127-17-CA SUBMITTED 9/7/17

# Proposed Landscape Improvements For 533 Watauga Street

127-17-CA 533 WATAUGA STREET Applicant: JOHN L THOMAS

<u>Nature of Project</u>: Landscape/site improvements: install outdoor kitchen, replace lantern on brick post, install brick walkway, build small deck, install patio, construct accessory building

Existing post fixture.

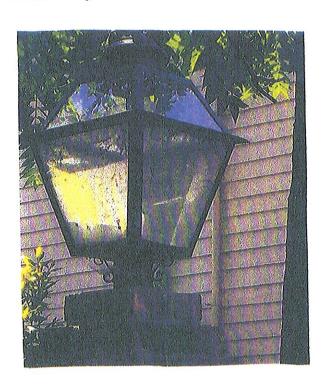
- 7\* A photograph was provided of a replacement lantern, but no specifications were given.
- 8\* The new patio extends the hardscape area into the lawn. It will be constructed of natural stone pavers with a fire bowl in the center of the north section, and it will be edged with sections of seat walls. It leads to a wall fountain on the west fence. Neither the stone pavers nor the wall fountain were presented with the application.

- b. Stone pavers;
- 3. That details and specifications for the following be provided to and approved by staff prior to installation or construction:
  - a. Lighting;
  - b. Wall fountain;
  - c. Deck stain/paint

Proposed Accessory Building McCulloch-533 Watauga Street

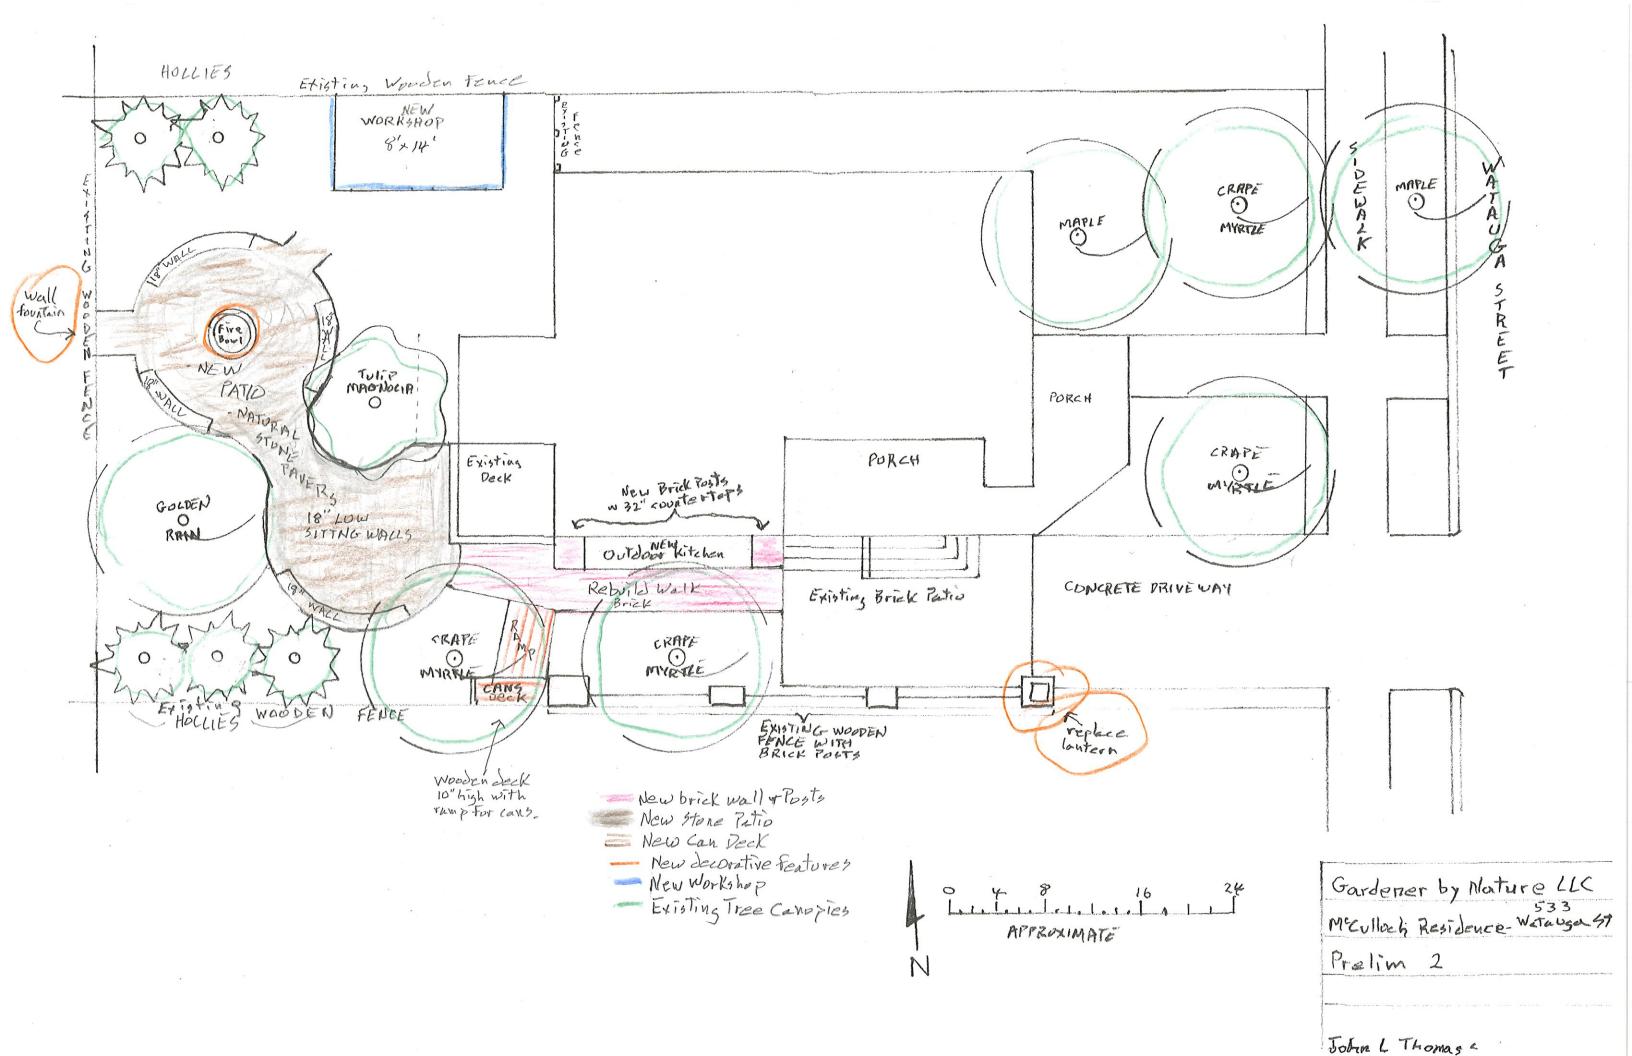
- 1\* The proposed workshop is 112 SF. The workshop will be clad in siding and painted to match the house. No indication was given regarding trim materials or roofing.

- 2\* Windows are shown on the elevation drawings, and appear to be either divided light or simulated divided light. No window specifications were provided.

- 3\* Doors are shown as a pair of barn-style doors on a top rail. No door specifications were provided.
- 4\* No specifications were provided for exterior lighting on the accessory building, although the application states that electricity will be run to it.

- 1. That details and specifications for the following be provided to and approved by staff prior to issuance of the blue placard for the accessory building:
  - a. Windows.
  - b. Trim materials;
  - c. Roofing;
  - d. Doors.
- 2. That details and specifications for the following be provided to and approved by staff prior to issuance of the blue placard for other items:
  - a. Elevation drawings or specifications for the kitchen;
